To: Summit County Council
From: Patrick J. Putt, Community Development Director
Date of Meeting: 1 March 2023
Type of Item: Dakota Pacific Park City Tech Center Amendment Public Hearing
Process: Legislative

DPRE Mixed Use Development Traffic Impact Study

Memo

Project Name: DPRE TIS Peer Review

FIGURE 2: MONTHLY ADT AT CCS 605

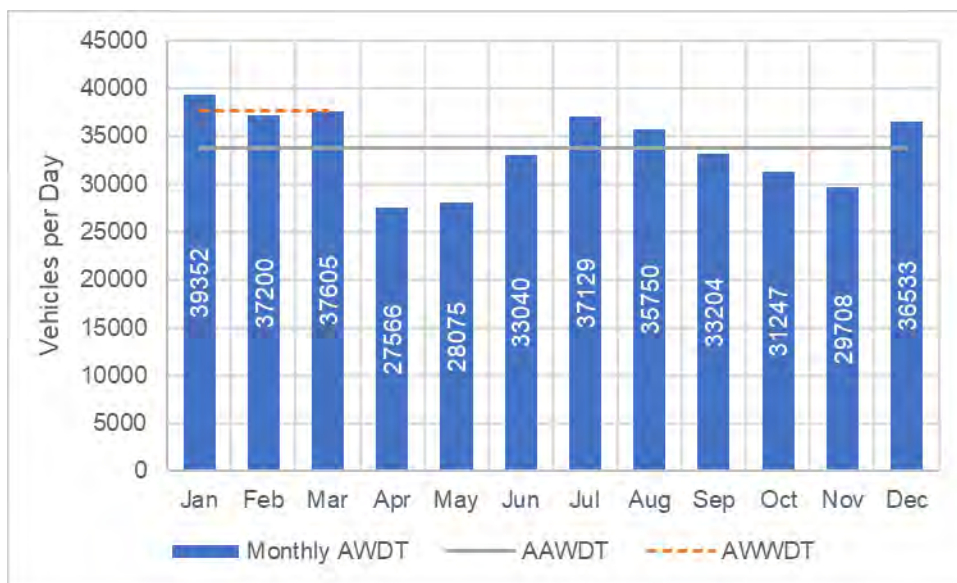
- The TIS did not apply a seasonal adjustment to any roadways or turning movements other than through trips on SR-224. Many of the land uses and routes within the project area may be impacted by seasonal variation in traffic volumes. *Please apply a seasonal adjustment throughout the project area or document why specific movements shouldn't be adjusted.*

WCG reviewed the monthly average weekday traffic at CCS 605, presented in Figure 2. The figure indicates that peak summer traffic volumes in July and August exceed average traffic volumes but remain below average winter weekday traffic volumes. Analysis of average winter weekday traffic volumes represents peak conditions.

FIGURE 4: LEFT-TURN INVOLVED CRASHES BY TIME OF DAY AT THE SR-224 & UTE BOULEVARD INTERSECTION (2017-2021)

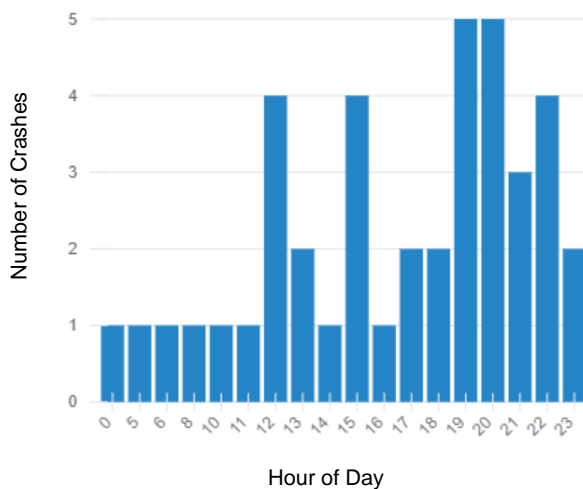
- The UDOT TIS Guidelines require an evaluation of safety and reported crashes in a traffic study for a proposed development of this size. The TIS did not perform a safety evaluation.
- The project area experienced a notable number of crashes. In particular, there were 8 severe crashes at SR-224 & Ute Boulevard from 2017 through 2021.
- None of the proposed mitigations addressed safety concerns. *Please perform a safety evaluation and consider if mitigation could address the number and severity of crashes within the study area.*

An initial review of current crash data indicates a large number of crashes in the study area in the most recent complete 5-year period (2017-2021). As an example, 115 crashes were reported at the SR-224 & Ute Boulevard intersection in the study period, and 8 of those were severe crashes. Six of the severe crashes were left-turn related, and all involved vehicles turning left from the northbound or southbound approaches. 41 of the crashes overall involved left-turning vehicles, and these crashes were clustered in the evening hours (see Figure 4).

The 2008 and 2021 TIS noted LOS E and LOS F conditions at the SR-224 & Ute Boulevard intersection in the PM peak hour, with operations improving to LOS D with the improvements included in the 2007 SBTMP. The 2022 TIS noted the SR-224 & Ute Boulevard intersection would operate at LOS D in the PM peak hour for all scenarios. The mitigation recommended in the 2022 report is limited to support for possible UDOT improvements and an additional northbound lane along SR-224 between Olympic Parkway and Ute Boulevard. It does not recommend any mitigation that would address a concern with northbound or southbound left turns at the SR-224 & Ute Boulevard intersection.
